03-15 LATEST REVISION DATE	 APPROVED BY BRIDGE ENGINEER	 STANDARD DESIGN - 40' ROADWAY, 3 SPAN BRIDGES ROLLED STEEL BEAM BRIDGES JUNE, 2010	
		SUBDRAIN DETAILS	RS40-170-10

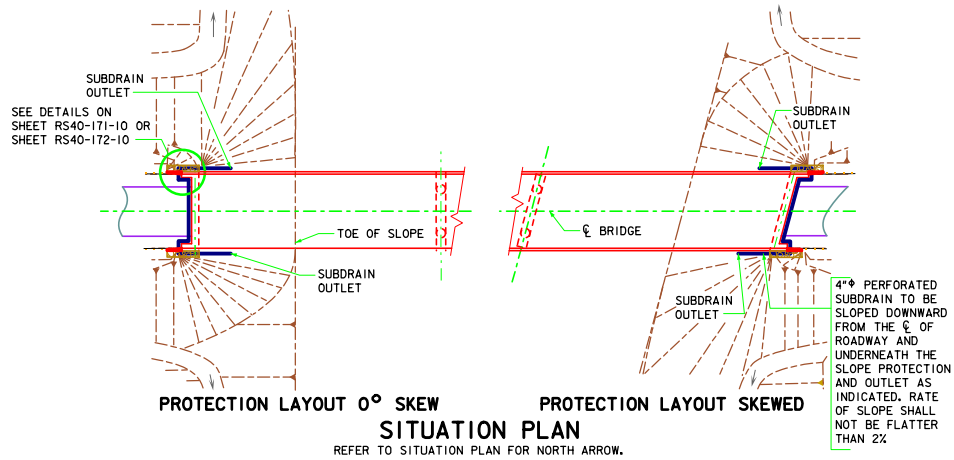
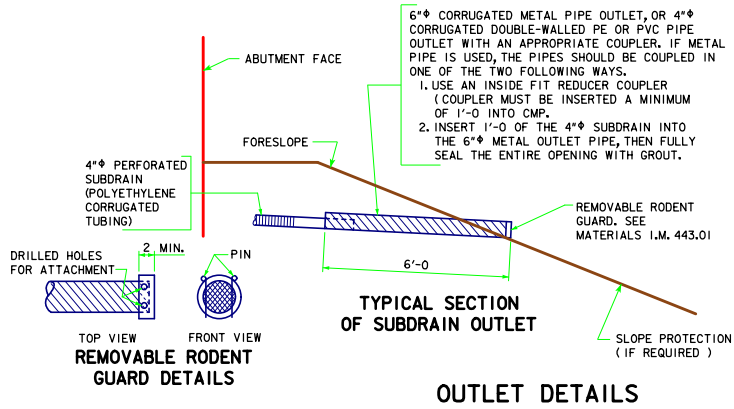
REVISED 03-15 CORRECTED THE CALLOUT "SHEET RS40-171-10 OR SHEET RS40-172-10" IT WAS IN ERROR CALLING OUT "SHEET H40-90-06 OR SHEET H40-91-06".
